Re: B.T.C.A. and Thickener Pond Area
C.V. Spur Processing Facility
ACT/007/022 # 2
Carbon County, Utah

Re: **Permit Boundary and BTCA's, Beaver Creek Coal Company, C. V. Spur Coal Processing and Loadout Facility, ACT/007/022-90A, Folder #2, Carbon County, Utah**

TO: Pamela Grubaugh-Littig, Permit Supervisor
FROM: Jeff Emmons, Reclamation Hydrologist *J.E.*
RE: **Permit Deficiencies and Amendments, Beaver Creek Coal Company, C. V. Spur Coal Processing and Loadout Facility, ACT/007/022-90A, Folder #2, Carbon County, Utah**

TO: Pamela Grubaugh-Littig, Permit Supervisor
FROM: Wm. J. Malencik, Reclamation Specialists *WJM*
RE: Permit Deficiencies/Coal Storage Area - C.V. Spur

C.V SPUR - SKETCH MAP

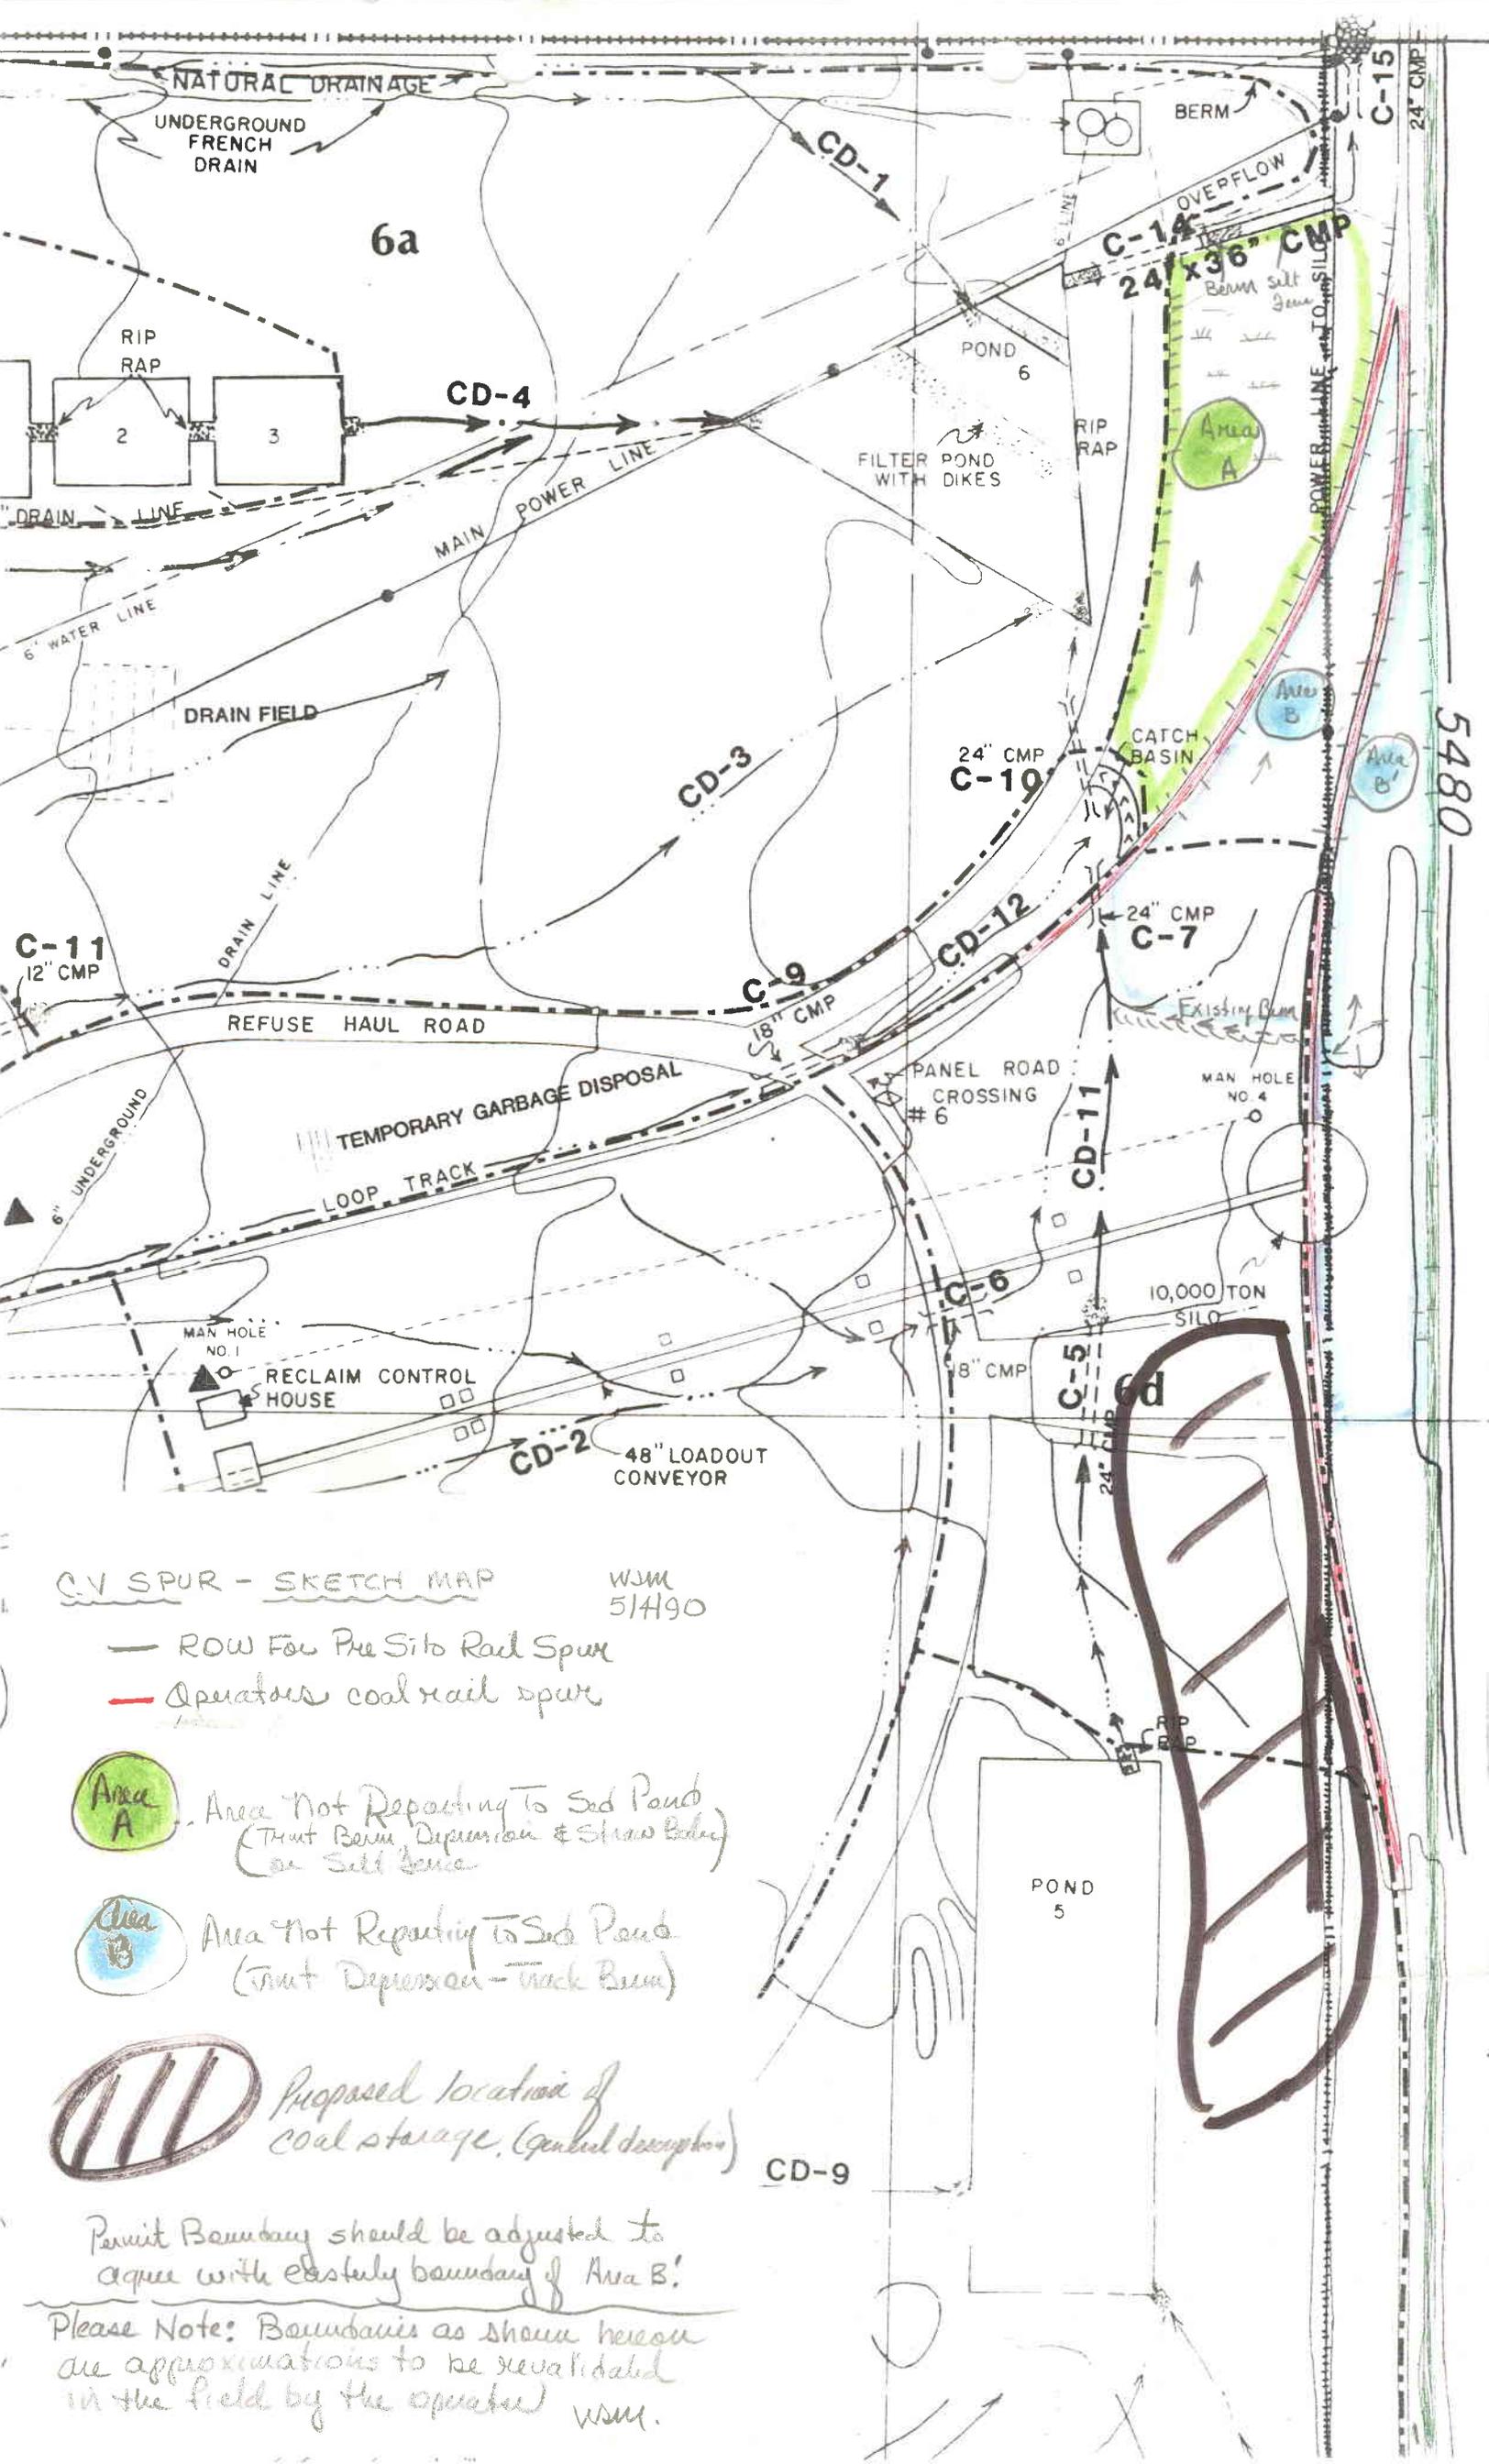
Item 1 Permit Deficiency. The current permit easterly boundary runs through the center of the coal silo. The permit boundary needs to be modified to include all of the silo area.

I recommend that the permit boundary be amended to coincide with the easterly boundary of the railroad ROW. Further, the operator amend Plate 3-2 and Figure 7-5 and submit such documents to the Division. Also the operator should submit a copy of the railroad ROW.

Item 2 Permit Deficiency. The current undisturbed boundary adjacent to the coal silo needs to be modified (Fig. 7-5). Further, the Areas A and B shown on the attached map do not drain into a sediment pond. However, a visual inspection revealed that no runoff is leaving the site. Nevertheless, these areas need to be treated and approved as areas exempt from reporting to a sediment pond. The areas we question cannot feasibly drain to a sediment pond.

- o Area A: Area A is a depression that drains into the sediment pond ditch. The upper end does not have a good stand of vegetation, however, the lower end has a good grass stand. Recommend the Area A be treated with a berm, and a silt fence or straw bales where it interfaces with the sediment pond ditch.
- o Area B: Area B lies in a depression between and/or adjacent to the railroad tracks. No evidence of runoff departing Area B could be detected. There was past evidence of standing water that was well below the containment berm.

The operator must designate the coal storage area on the surface facilities map. Further, the coal should not be stored any closer than twelve (12) feet to the operators railroad tracks. Also a small buffer area should be kept open that would prevent coal from falling in to adjoining ditch and sediment pond.

Area Not Reporting to Sed Pond
(Trout Berm Depression & Straw Bales)
See Self fence

Area Not Reporting to Sed Pond
(Trout Depression - track Berm)

Proposed location of
coal storage. (General description)

Permit Boundary should be adjusted to
agree with eastern boundary of Area B!

Recommend that the operators proposal be considered as exempted areas from reporting to the sediment ponds providing he

1. Submits amended maps and text
 2. Calculates the area within Areas A and B
 3. Calculates the potential runoff for Area B to demonstrate total containment and
 4. Maintains samples and TSS and SS water quality records of any flows through silt fence.
- Negative or no flow reports are not required.
